Access Compliance Report

Public Rights-of-Way

Intersection ID: 43210	Main Street: ENDERLY_RD	Cross Street: MATHIS_DR	Location:	E
ADA ID: BA641E399FB8	Ramp Type: PerpDiag	Initial Pass/Fail: Fail	Overall Compliance: No	Severity Score: 10

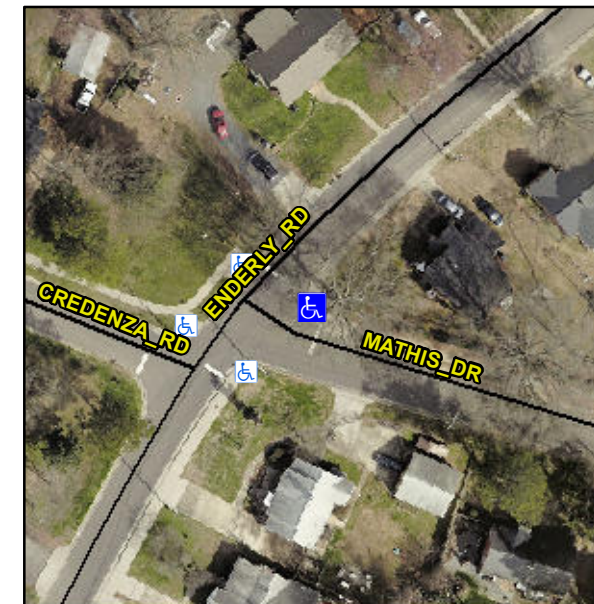
Not Found, R304.5.1, R304.5.3

Compliance	Description	Data	Compliance	Description	Data
N/A	Ramp Length (in)	74.0	Yes	Ramp Slope (%)	5.7
No	Ramp Width (in)	41.0	No	Ramp XSlope (%)	4.0
N/A	Flare Type LT	N/A	N/A	Flare Type RT	N/A
N/A	Flare Slope LT (%)	N/A	N/A	Flare Slope RT (%)	N/A
N/A	Flare Traversable LT?	N/A	N/A	Flare Traversable RT?	N/A
N/A	Landing Length (in)	N/A	N/A	DWS Provided?	N/A
N/A	Landing Width (in)	N/A	N/A	DWS Contrast?	N/A
N/A	Landing Slope (%)	N/A	N/A	DWS Length (in)	N/A
N/A	Landing X Slope (%)	N/A	N/A	DWS Full Width?	N/A
N/A	Landing Curb? (Y/N)	N/A	N/A	DWS Offset (in)	N/A
N/A	Shared Landing?	N/A			
N/A	Gutter Ponding?	N/A	N/A	Gutter Slope (%)	N/A
N/A	Gutter Lip Ht (in)	N/A	N/A	Gutter X Slope (%)	N/A
N/A	Painted X Walk1?	No	N/A	Painted X Walk2?	No
	X Walk 1 Direction	To NW		X Walk 2 Direction	To SW
N/A	X Walk 1 Width (in)	N/A	N/A	X Walk 2 Width (in)	N/A
	X Walk 1 Slope (%)	2.3		X Walk 2 Slope (%)	1.1
	X Walk 1 X Slope (%)	2.4		X Walk 2 X Slope (%)	2.0

Remove & Replace Curb Ramp With Two New Directional Ramps or Equivalent.
